**PROJECT NAME:: FACD08 RESTROOMS AT PREBLE TRUCK PARKING**  
**PROJECT No.: DOT-250005**

**ADDENDUM NUMBER ONE (1)**

February 27, 2026

SHEET  
**C.116**

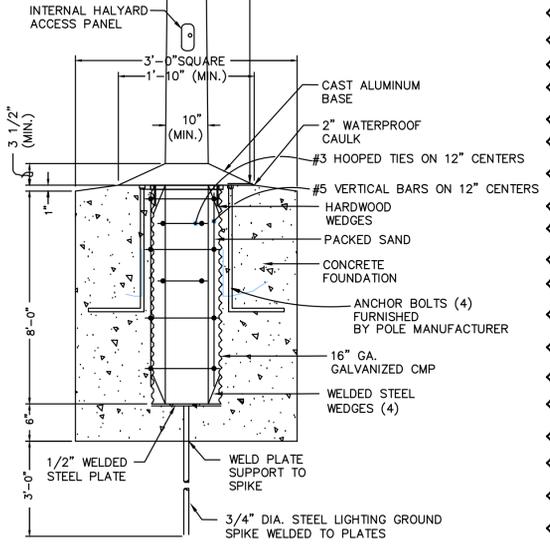
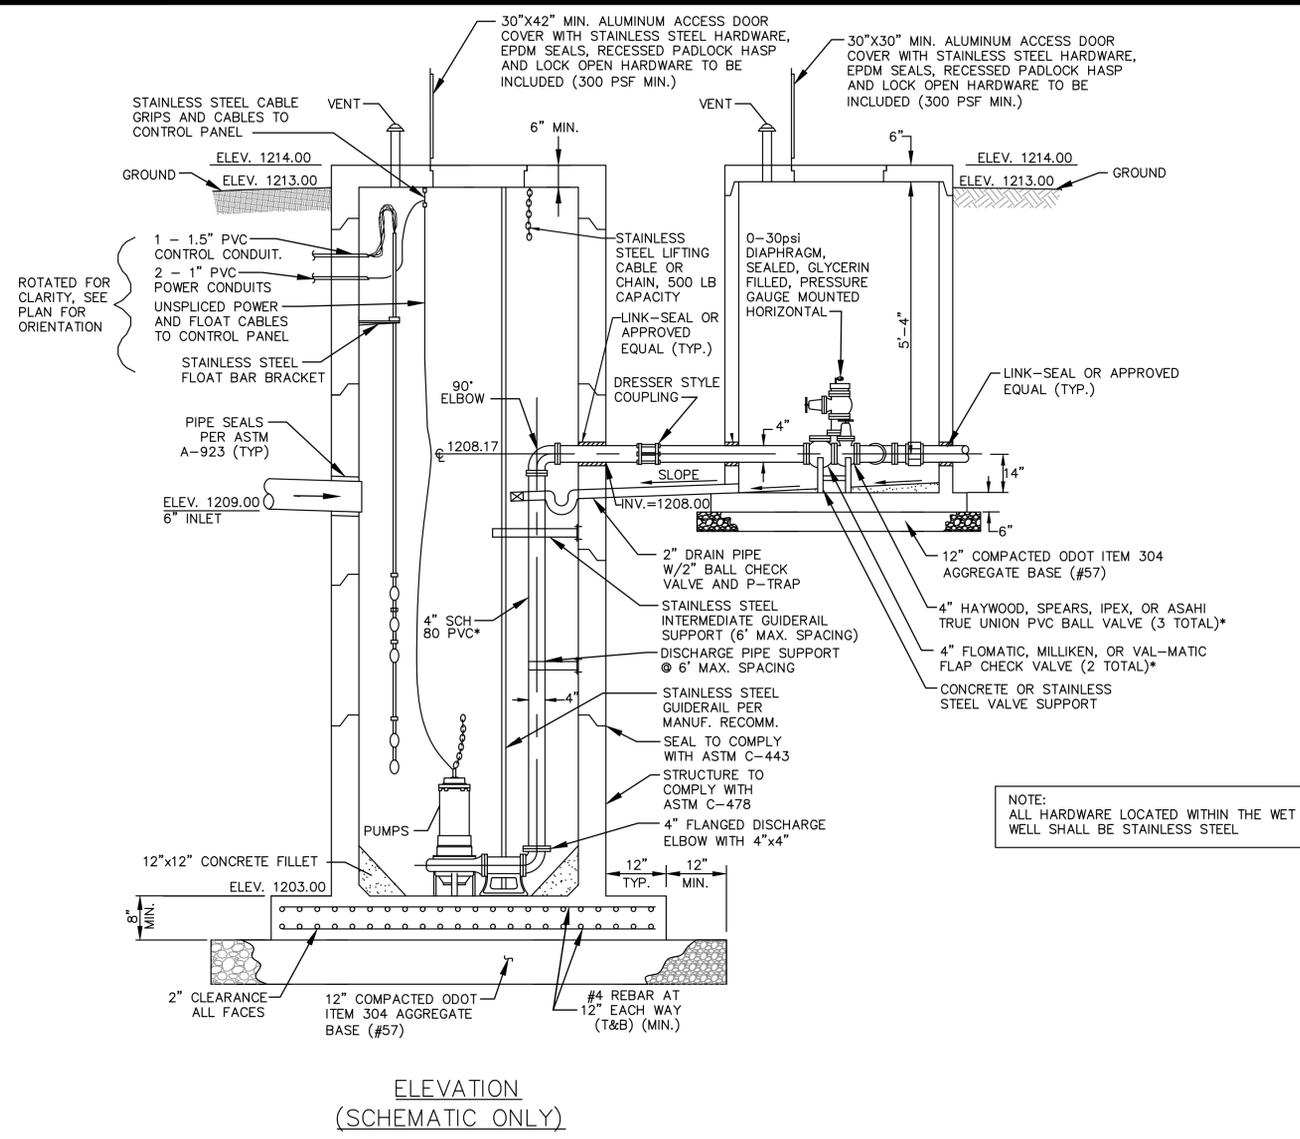
D-01. C.116 Flag pole detail was revised

**RFI-2.** What is the height of the flagpole? The Specification says it is 60 ft, but the Drawing says that it is 40 ft?

**RFI-5.** The butt diameter listed in the specifications is 10". However, if the flagpole is 60 ft high, the butt diameter would need to be 12". Please clarify?

- . **Response:** The flagpole should be 60' tall., see C.116 Flag pole detail

- . **Response:** See revised C.116 Flag pole detail

- FLAG POLE REQUIREMENT NOTES:**  
 FLAG POLE HEIGHT: 60'  
 MAXIMUM WIND SPEED UNFLAGGED: 135 MPH  
 MAXIMUM WIND SPEED FLAGGED: 106 MPH  
 MAXIMUM FLAG SIZE: 12 X 8 FEET  
 ALUMINUM CONE-TAPERED FLAG POLE, ASTM B241, ALLOY 6063  
 EXTERNAL HALYARD, FLAG SNAPS, CAST METAL CLEAT COVER, CYLINDER LOCK 60-INCH HALYARD COVER (FINISH TO MATCH FLAG POLE)  
 FINAL BALL  
 CLEAR ANODIC FINISH (AAMA 611, AA-M12C22M41, CLASS 1, 0.078mm THICK)  
 FOUNDATION TUBE FOR ALIGNMENT AND REPLACEMENT WITH POLE LIGHTING GROUND

SHEET  
**C.117**

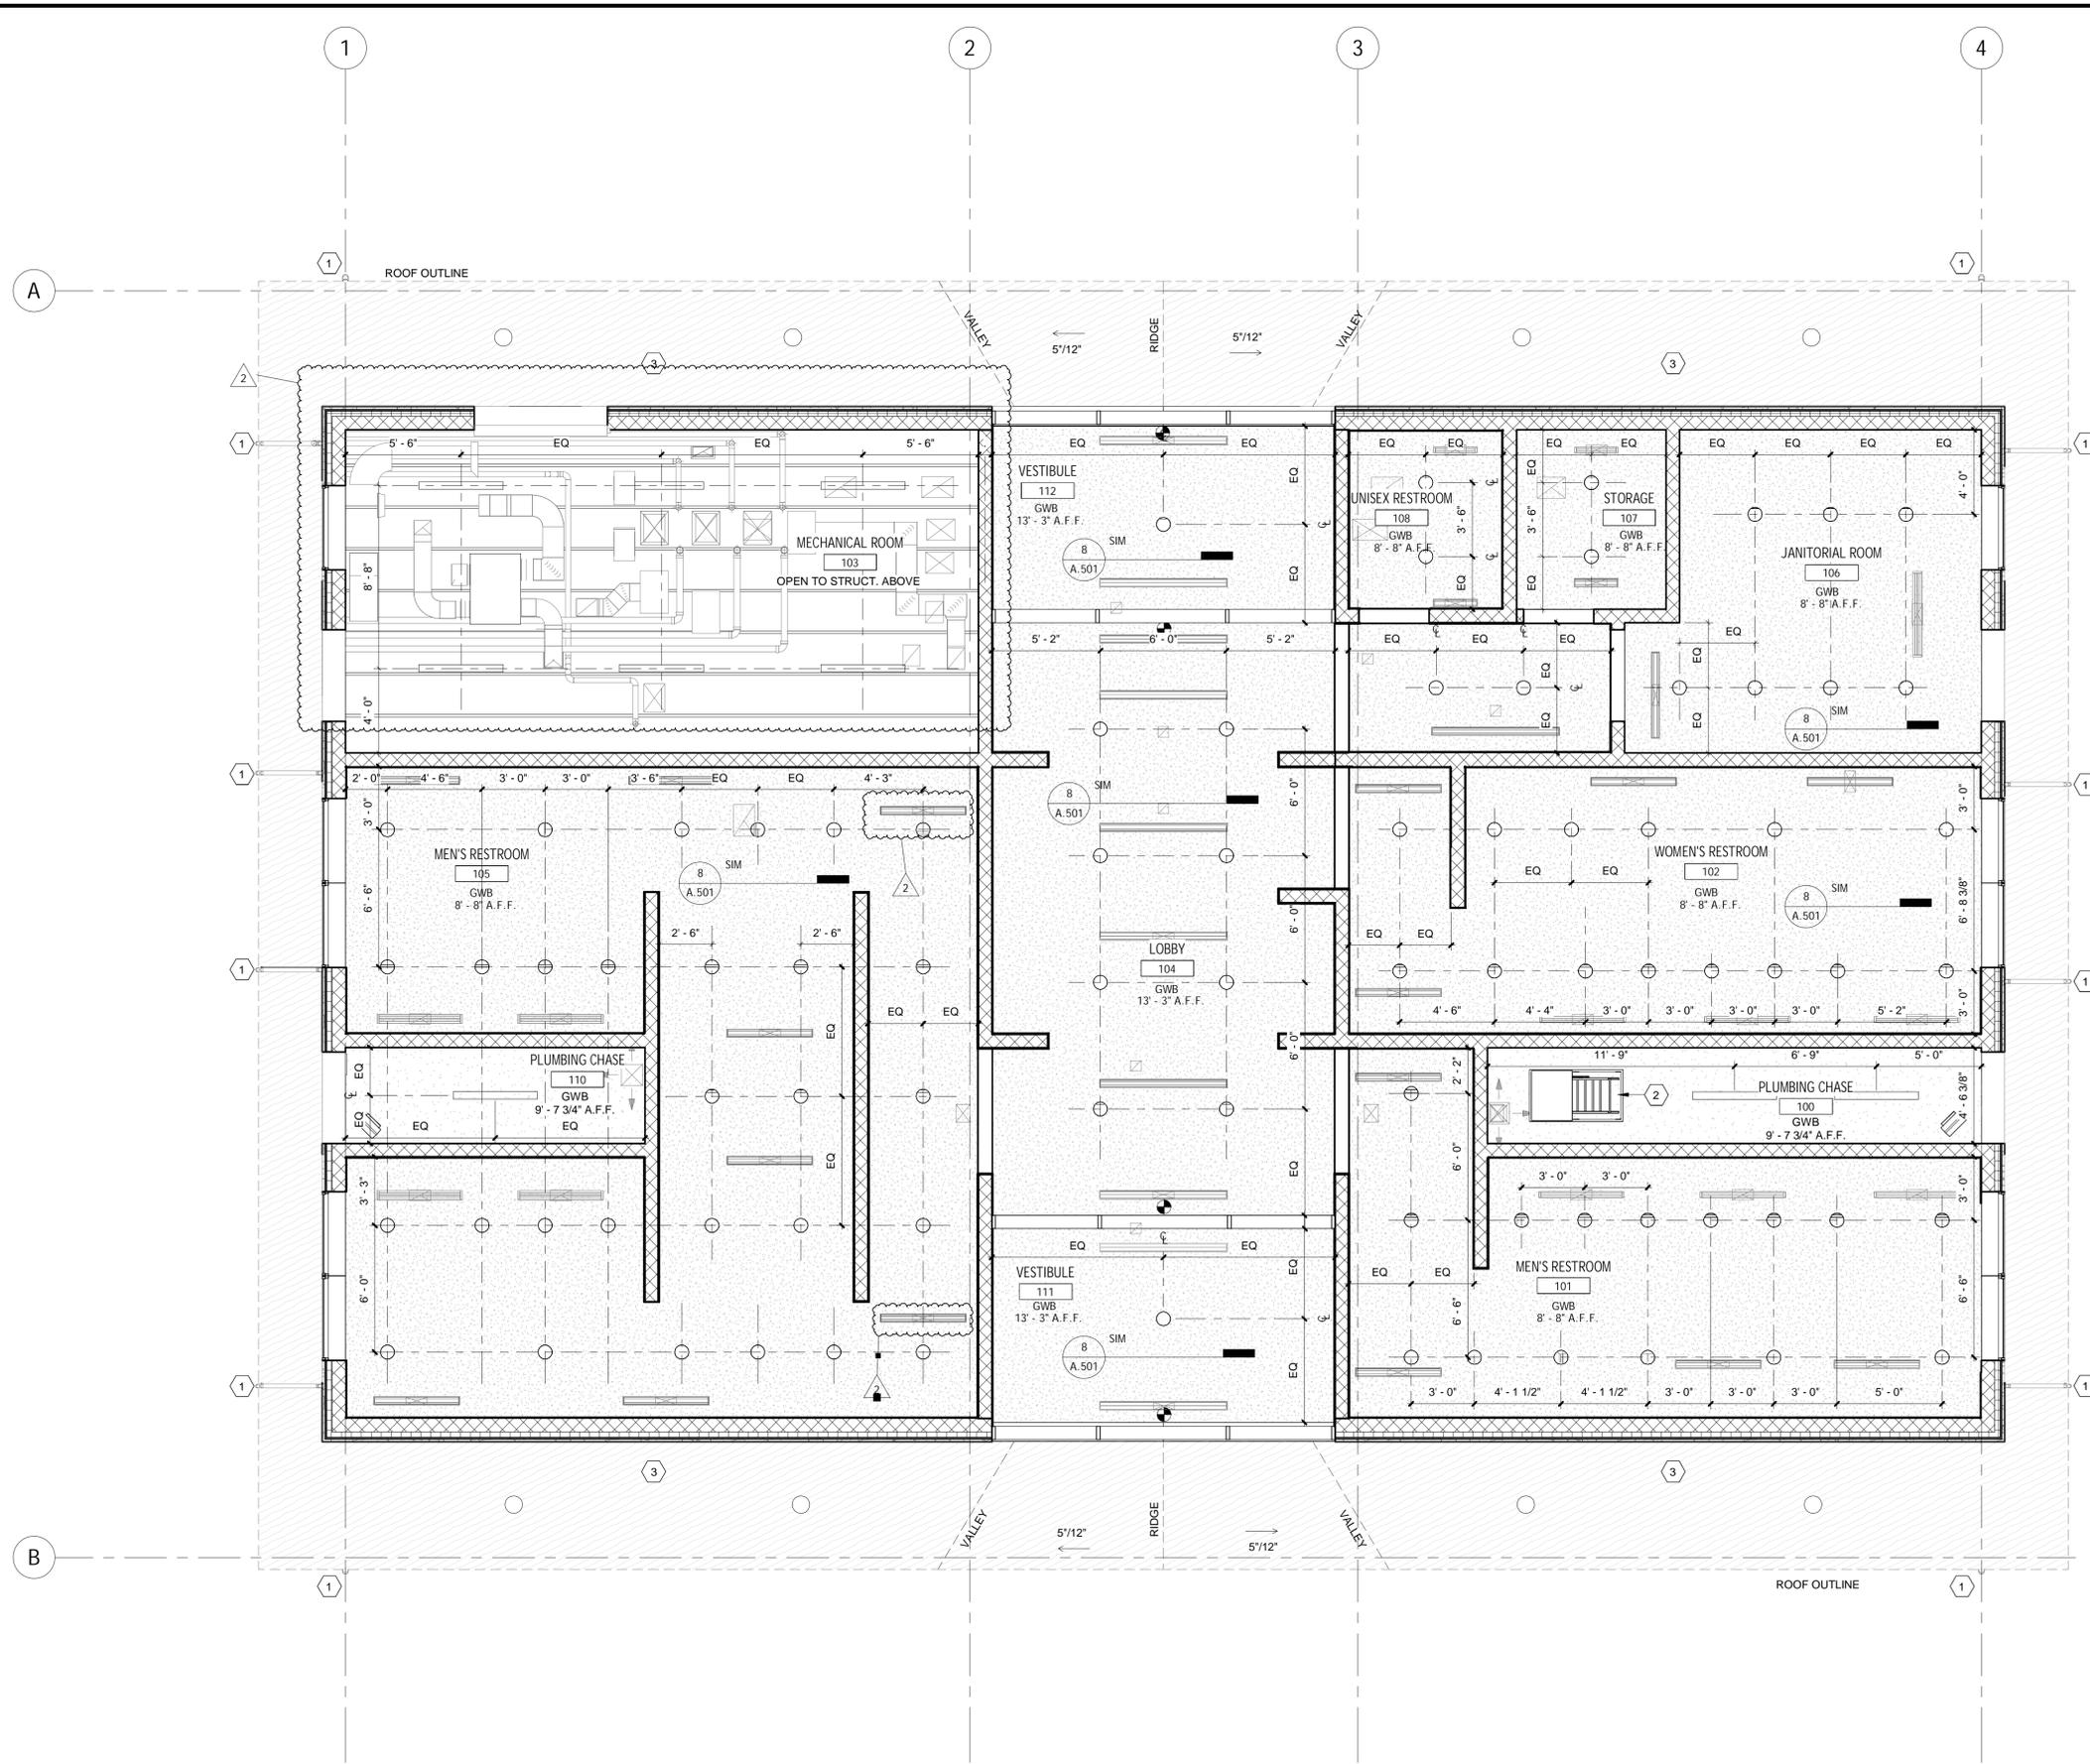
D-02. C.117 Lift station Inside Diameter was revised

**RFI-9.** I wanted to confirm the wet well depth before putting my proposal together. The drawing shows 36" dia and the specifications describe a min. 5'-0" or (60") dia. wet well. Please confirm the wet well and dia.

- . **Response:** it is 5'-0" in dia

SHEET  
**A.300**

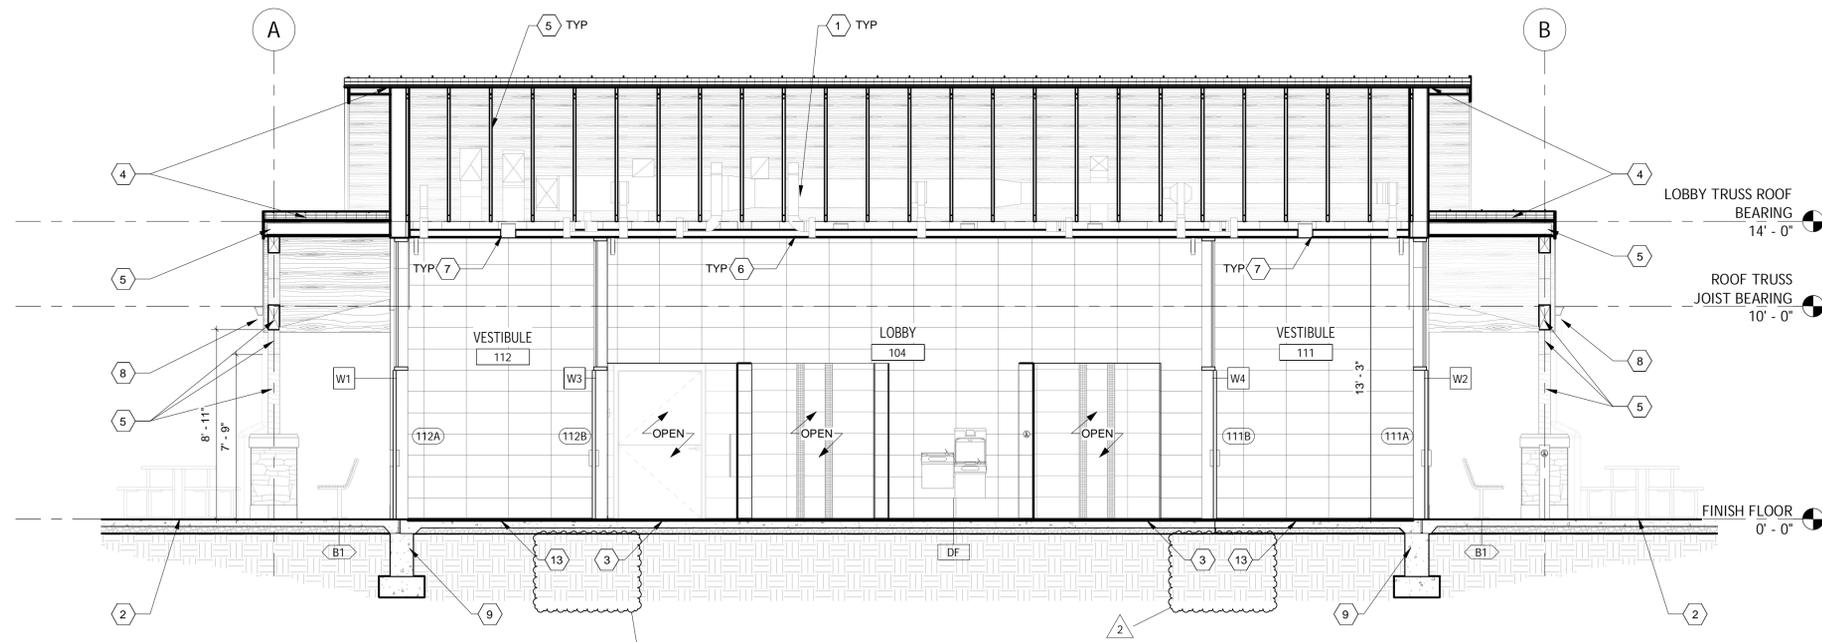
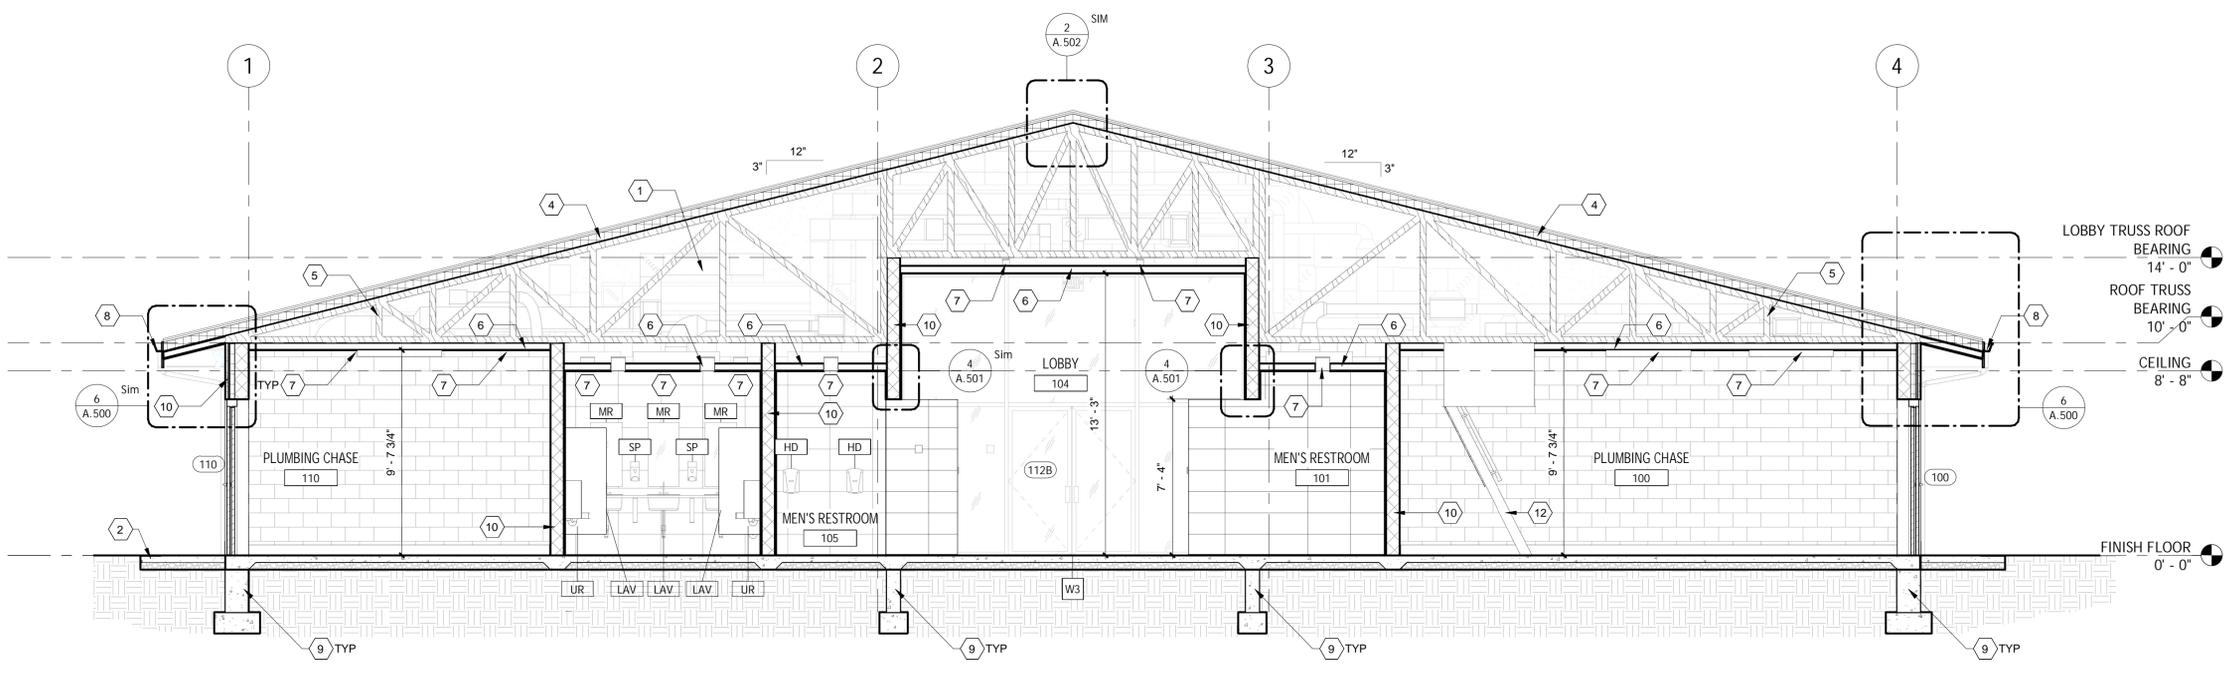
D-03. A.300, A.302, A.501, A.600, A.601 Verbiage and detailing were added for walk off mat installation.

- BUILDING SECTION CODED NOTES**
- MECHANICAL EQUIPMENT. SEE MECHANICAL DWGS FOR MORE INFORMATION
  - FINISHED GRADE, AS OCCURS
  - CONCRETE FLOOR, REFER TO STRUCTURAL DRAWINGS
  - ROOF, AS OCCURS
  - STRUCTURAL MEMBER, TYP, REFER TO STRUCTURAL DRAWINGS
  - CEILING, REFER TO CEILING PLAN
  - LIGHTING, REFER TO ELECTRICAL PLANS
  - GUTTER, REFER TO ROOF PLAN
  - FOUNDATION AND FOOTER, REFER TO STRUCTURAL PLANS
  - WALL, AS OCCURS, REFER TO DIMENSIONED FLOOR PLAN WALL TYPE SCHEDULE
  - VENDING ALCOVE WALL
  - ATTIC ACCESS LADDER
  - DEPRESS SLAB 3/4" FOR WALK OFF MAT INSTALLATION
